CITY OF SEASIDE
BOARD OF ARCHITECTURAL REVIEW

MEETING
COUNCIL CHAMBER
440 Harcourt Avenue
Wednesday, September 16, 2015
5:30 PM

Item No.: 5.A.

SUBJECT: Architectural Review Application No. BAR-14-32. Bahman Ben Ahmadi, property owner and applicant, requests design review approval to construct a second story addition onto the existing Rod and Ros service station located at 1898 Fremont Boulevard in the Commercial Mixed Use (CMX) Zoning District. This project is exempt from the California Environmental Quality Act pursuant to Class 1, Section 15301.e.1: Existing Facilities. (Continued from April 1, 2015)

WEST ELEVATION.

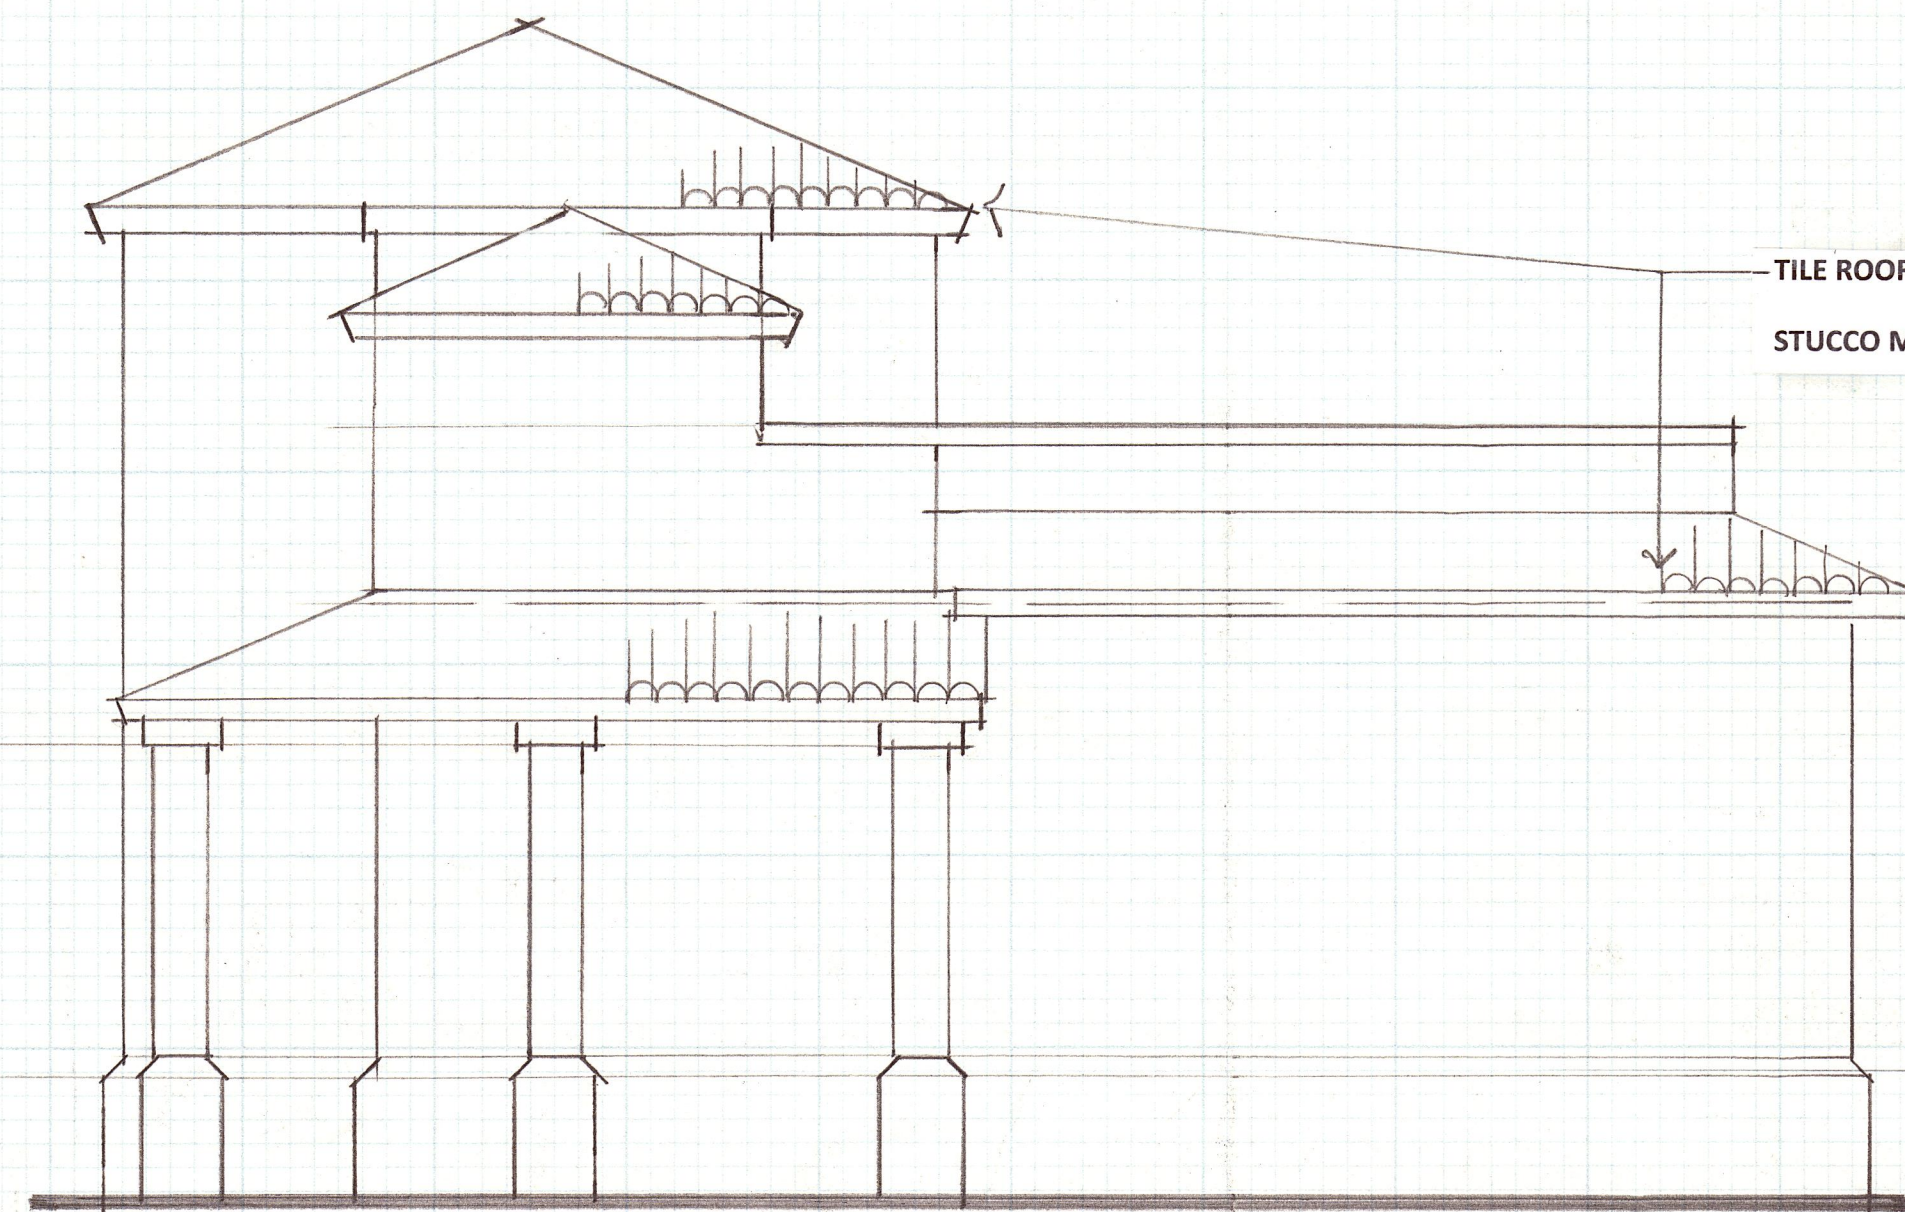
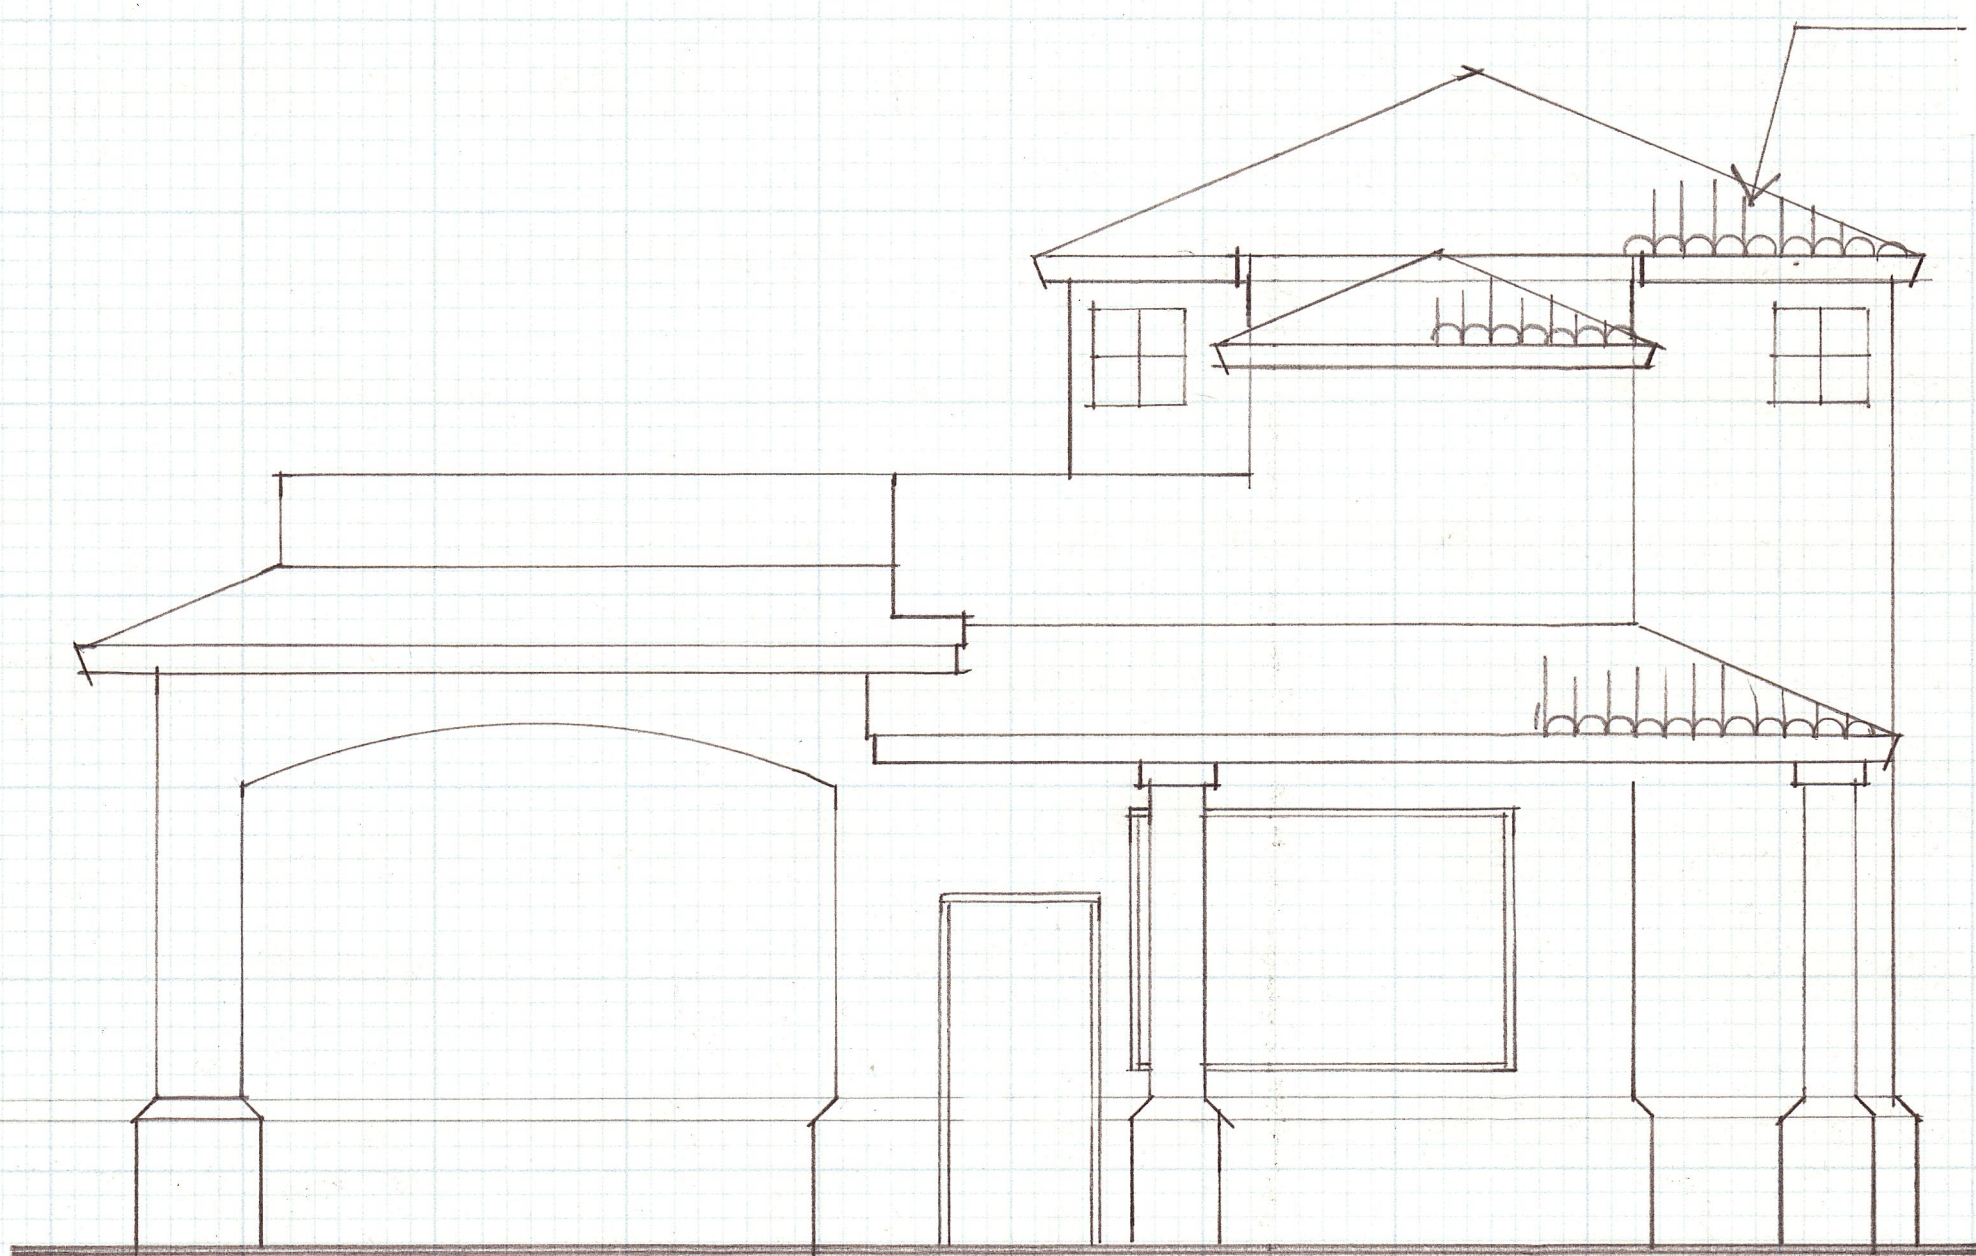
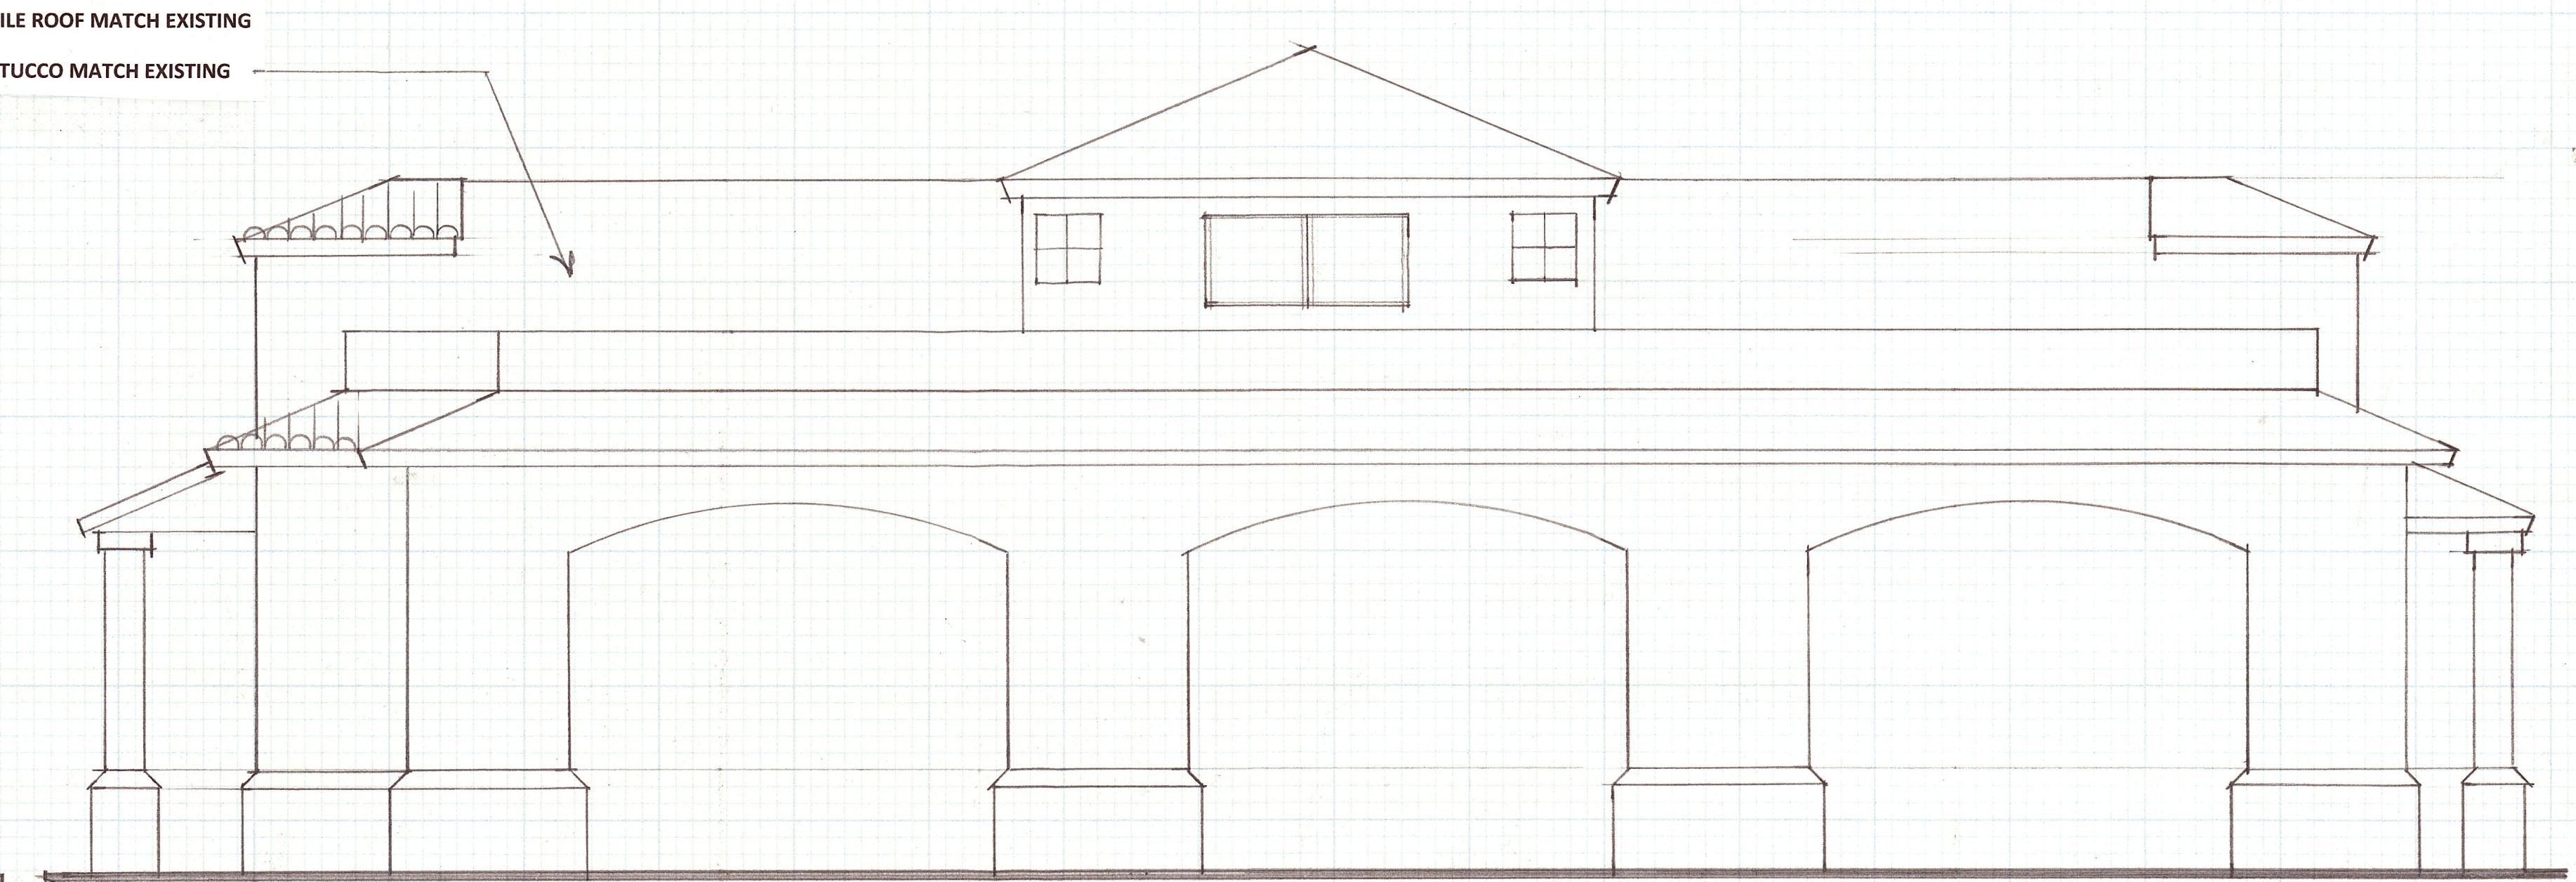
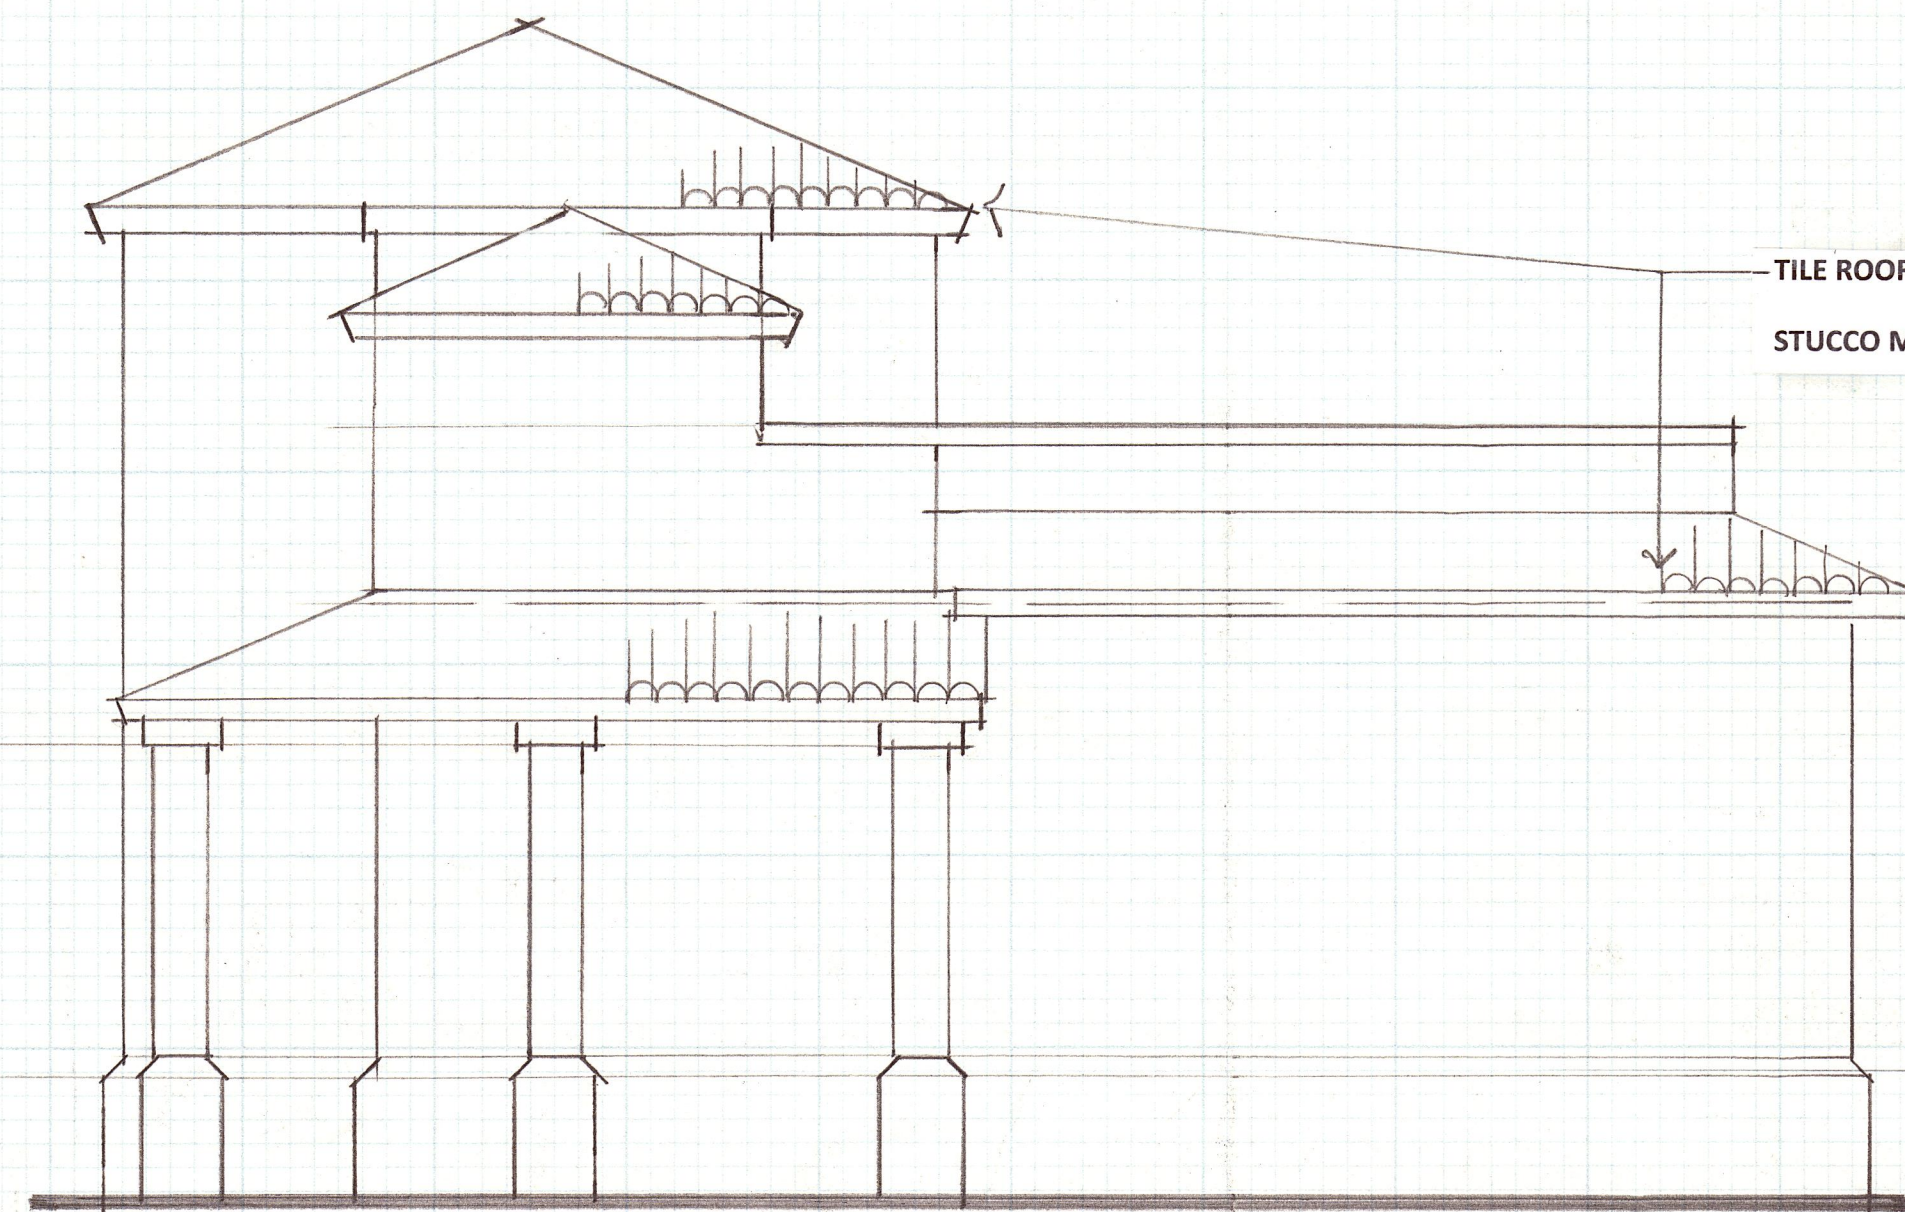
1. Provide a section through the building indicating the height of the office, stairway, and other details of the proposed design.
2. Specify whether the existing transom windows over the front doors will remain or if they will be modified per the colored rendering and Sheet 4 (exterior elevations).

3. Review alternative exterior designs and how they can better complement the existing exterior of the building. These elements include continuing the hip roof all the way across the front of the addition, colors, and material selections.

The applicant has submitted additional information in the form of revised exterior elevations, sections, and a color rendering.
